## Technical Services Memo

**To:** Don Allin  
**From:** Neil MacFarlane  
**CC:** File  
**Date:** July 26, 2024  
**Subject:** 192 County Road4, Township of Douro-Dummer  
**Roll #:** 1522 010 004 10500  
**File:** PPLD-2315

Figure 1 - Snapshot of Site Grading Plan

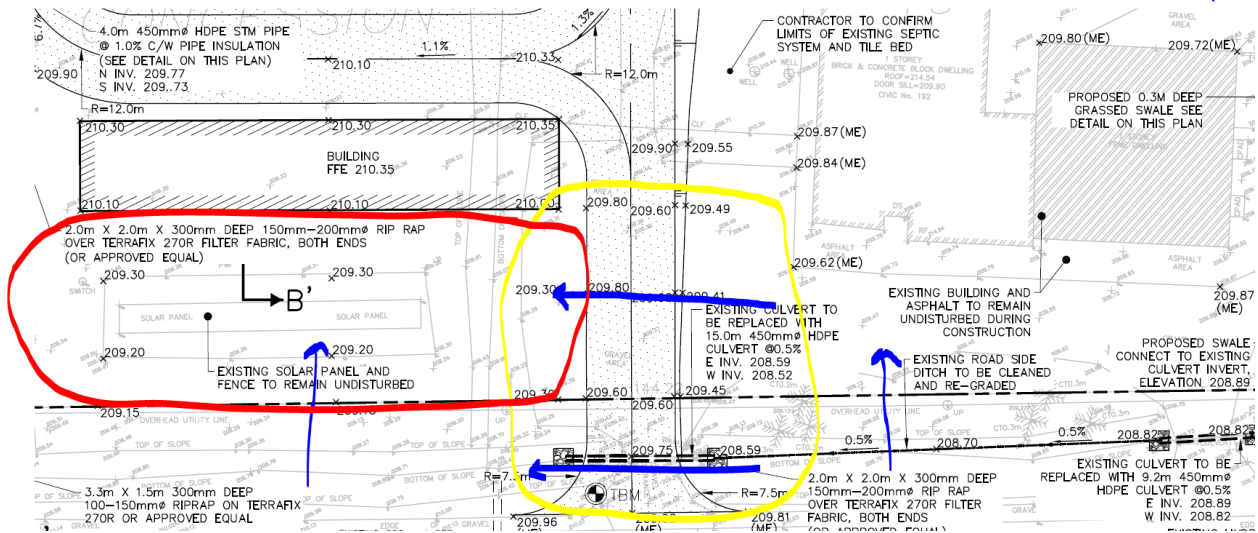
1. Under existing conditions, flood water is conveyed onto/across the site as represented by the blue arrows on Figure 1.
  - a) Under the proposed conditions, with the new raised laneway and raised entrance, the flood water needs to rise above 209.60m to spill across into the floodplain storage area identified by the red line on Figure 1.

- b) With the laneway grades being raised to 209.80m, the flood water is not spilling into the storage area.
- c) Please add multiple cross-culverts to allow flood water to be conveyed into the provided flood storage area.
- d) With flood water not crossing the laneway and blocked flows through/along the ditch by grading for the entrance, does the cut & fill balance need to be adjusted?
